RESPONSIVENESS SUMMARY

REMEDIAL INVESTIGATION REPORT WEST VAN BUREN AREA WQARF REGISTRY SITE PHOENIX, ARIZONA

August 8, 2012

FIGURE 1-1
SITE BOUNDARY
WEST VAN BUREN WQARF SITE
PHOENIX, ARIZONA

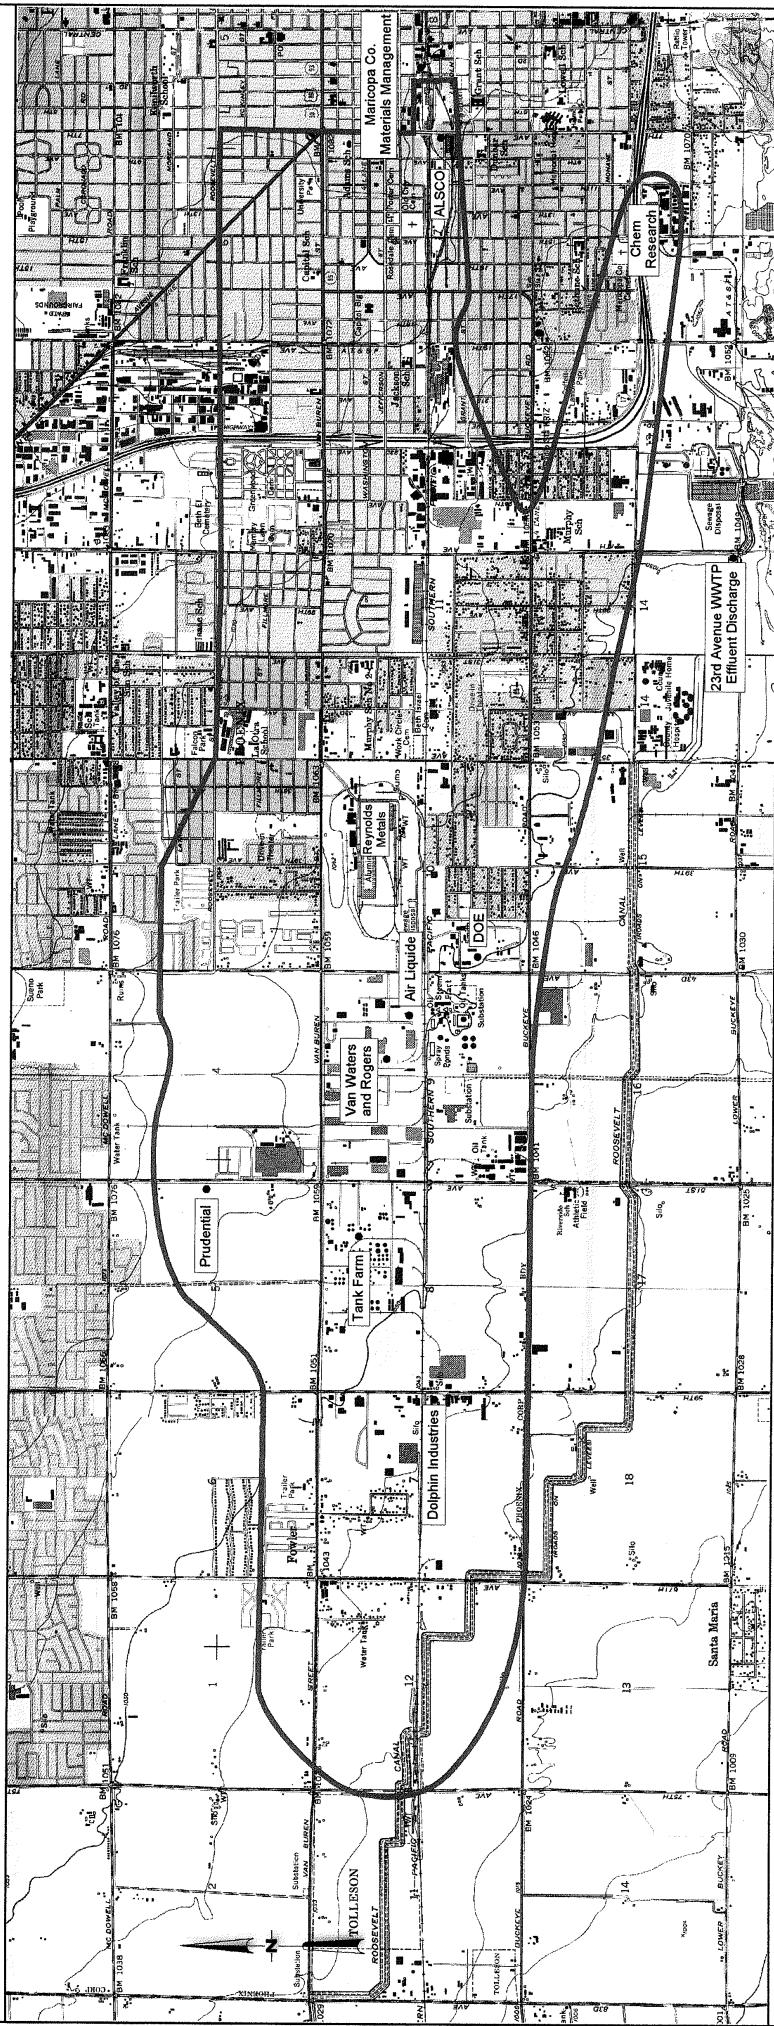
Page 1-2, 1.3.1 Site Description. “The WVBA extends from 7th to 75th Avenues and from Buckeye Road to Interstate 10 (Figure 1-1). Figure 1-1 does not show Interstate 10. Someone unfamiliar with the streets in Phoenix would read the above sentence and look for I-10 to be below Buckeye Road. Convention has boundaries called out or described East to West and North to South. ADEQ’s Site Description, dated 06/2008, describes the site as being bounded “approximately by McDowell Road to the north, 7th Avenue to the east, Buckeye Road to the South and 75th Avenue to the west.” Unfortunately the Draft RI Report is not as clear in its description nor in the attached figure.

- Page 1-2, 1.3.1 Site Description. “The WVBA extends from 7th to 75th Avenues and from Buckeye Road to Interstate 10 (Figure 1-1). Figure 1-1 does not show Interstate 10. Someone unfamiliar with the streets in Phoenix would read the above sentence and look for I-10 to be below Buckeye Road. Convention has boundaries called out or described East to West and North to South. ADEQ’s Site Description, dated 06/2008, describes the site as being bounded “approximately by McDowell Road to the north, 7th Avenue to the east, Buckeye Road to the South and 75th Avenue to the west.” Unfortunately the Draft RI Report is not as clear in its description nor in the attached figure.

- ADEQ Response: The text has been edited to better describe the approximate extent of the WVBA.
